Factory Service Bulletin

SUBJECT: MEMORYMOOGS BELOW S/N 2531
PITCH BEND AMOUNT MODIFICATION
PARTS TO BE PURCHASED LOCALLY

BULLETIN: 837

DATE: November 11, 1983 (Supersedes earlier versions of Bulletin 837)

COMMON ANALOG BD.

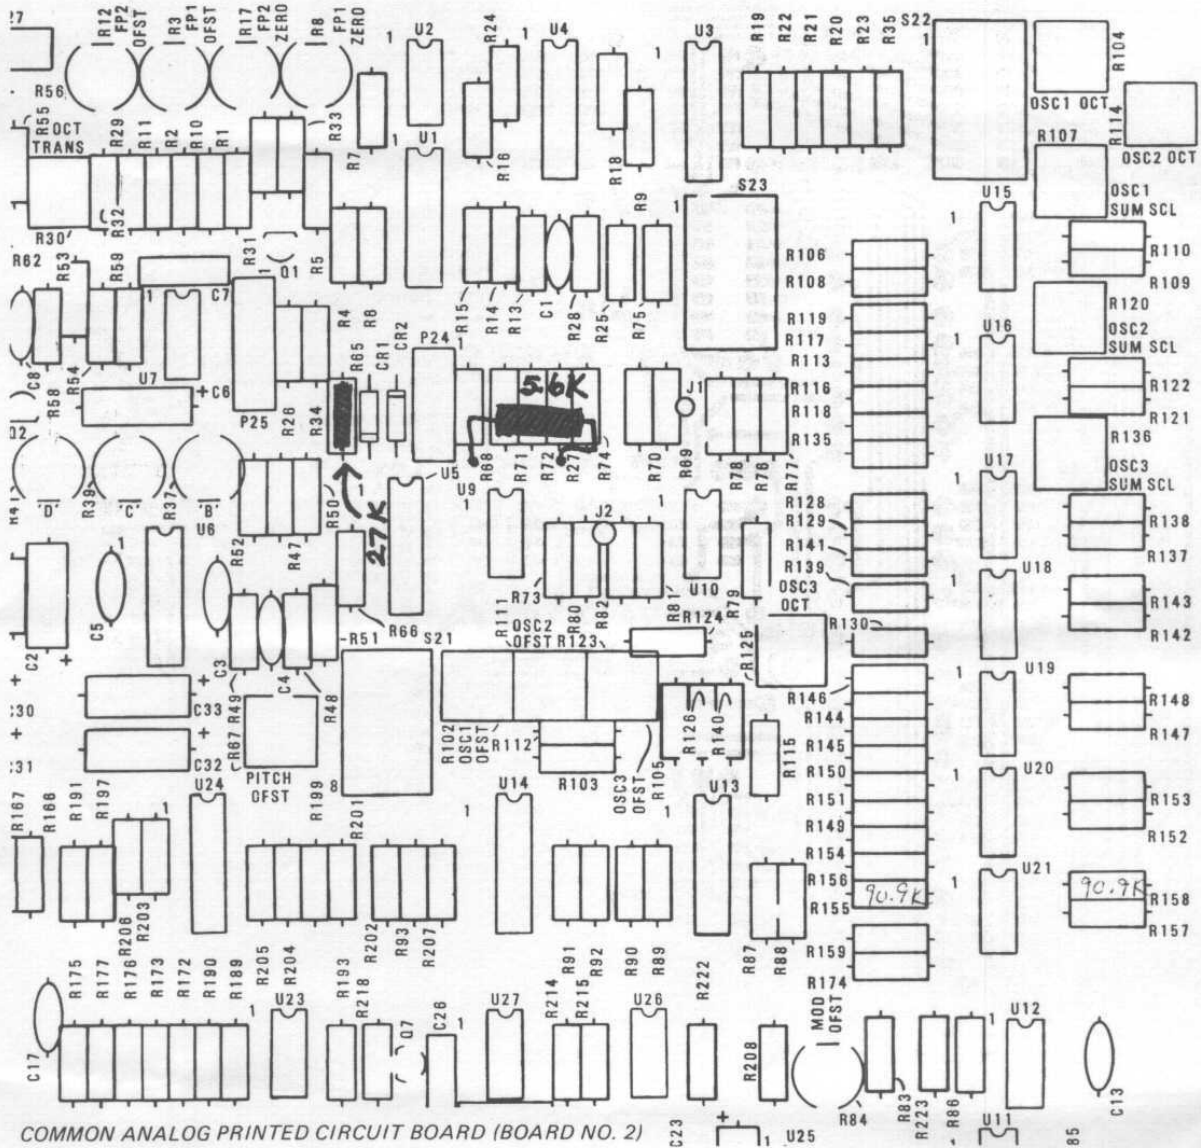
SYMPTOMS: Tuning changes from preset to preset, caused by different programmed PITCH BEND AMOUNTS which detunes all the oscillators.

CAUSE: The PITCH BEND VCA U5A on the COMMON ANALOG BOARD develops a non-linear output offset current which varies with the control voltage on Pin 5. This modification greatly improves linearity.

- 1) Tack-solder across R65 (560K) a 27K 5% resistor, part number 852-312273-001, on the TOP (component) side of the COMMON ANALOG BOARD.
- 2) Tack-solder a 5.6K 5% resistor, part number 852-312562-001, from the front side (U9 side) of R68 (100K) to the front side of R27 (4.99K).

- 1) Draw in a 27K resistor across R65.
- 2) Draw in a 5.6K resistor from Pin 2 of U5A to ground.
